ASME Section XI Update

**PDI/NRC Meeting
Spring 2012**

Ronnie Swain
June 18, 2012

Figure I-3200 Ferritic, Austenitic or Dissimilar Metal Weld
(Sides are defined in relationship to search unit placement)

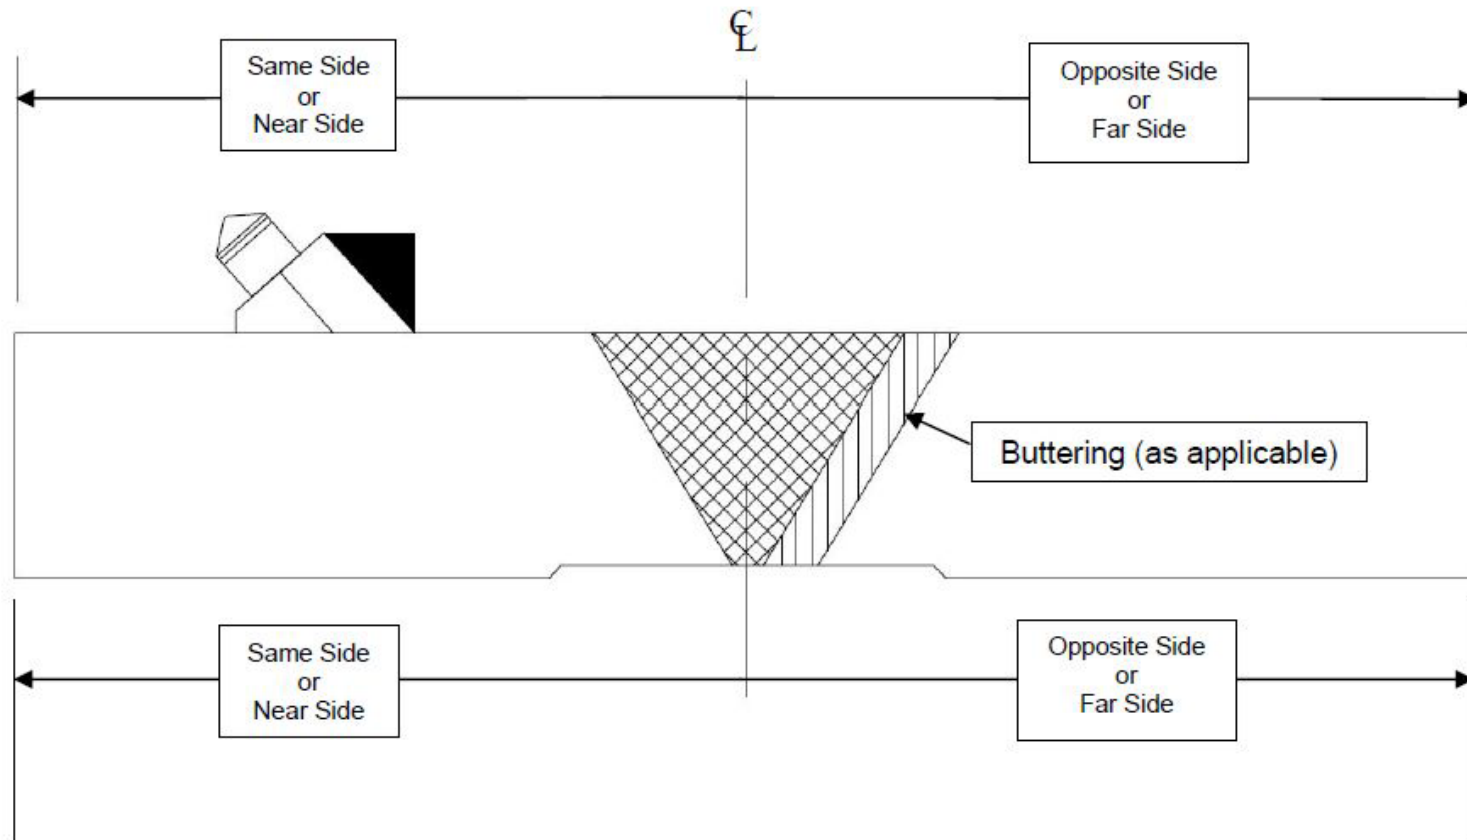
- In response to a request to clarify “opposite side of the weld” used in Article I-3200 (b) and (c), the addition of an illustration or figure was proposed.
- Initially, presented as an Intent Inquiry.
- After some discussion, the decision was made to instead present this as a Code Change.
- The proposed figure will be captioned “Figure I-3200 ...” (see next slide).

(10) VIII-3120 SIZING

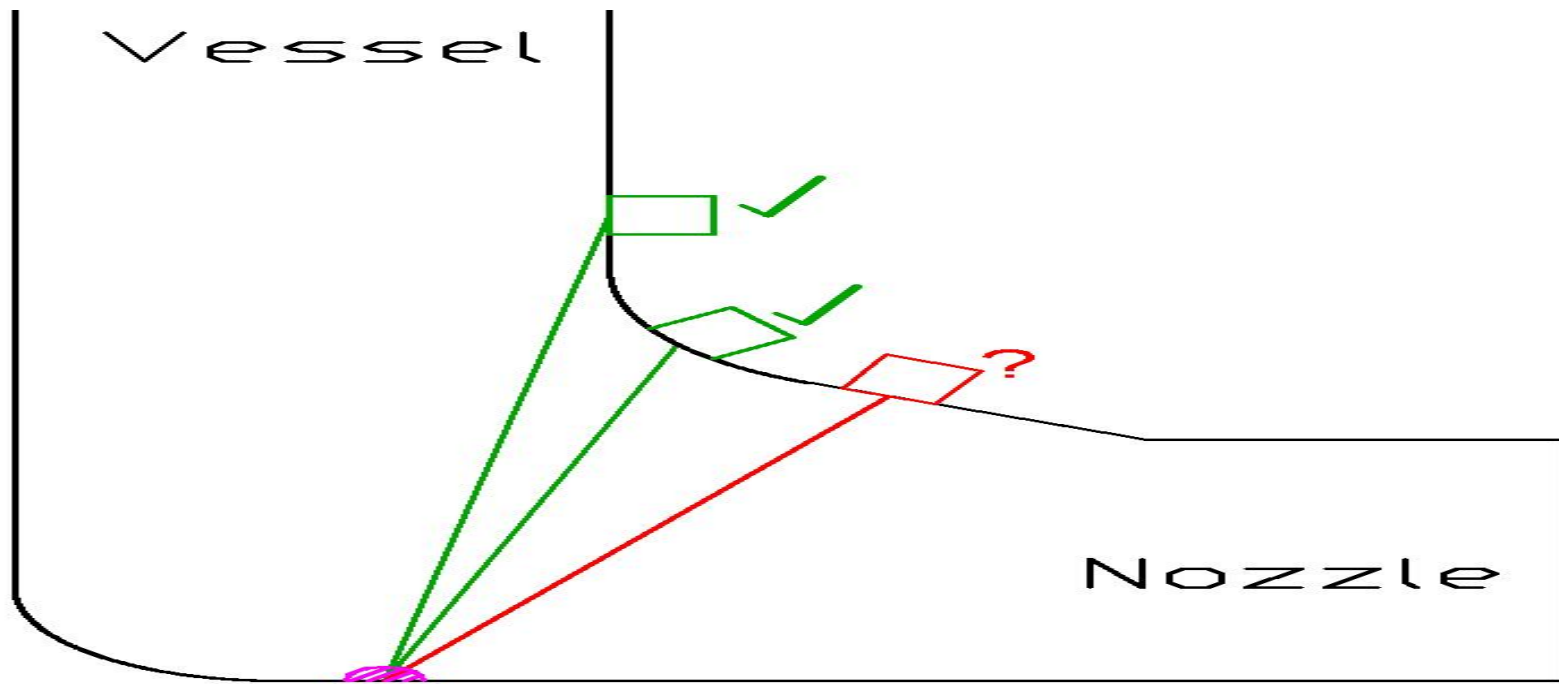
- This Code section allows the use of personnel, equipment and procedures qualified for sizing **Circumferential flaws** to be used for sizing **Axial flaws**.
- This is allowed when the appropriate Supplement contains no provisions for sizing axial flaws.
- While this may be feasible in some configurations, the words personnel, equipment, procedures “***and the associated essential variables***” become a problem in many situations
 - Unique wedge contour for circ scans vs. axial scans (with unique wedge model number)
 - Steeper examination angle may be needed

When the applicable piping supplement contains no provisions for a performance demonstration using axially oriented flaws, examination personnel, equipment, procedures, and the associated essential variables qualified for sizing on circumferentially oriented flaws shall be used. **Certain essential variables may be altered (e.g., examination angle, wedge contour, etc.) when necessary to perform the equivalent qualified flaw sizing techniques on axially oriented flaws.**
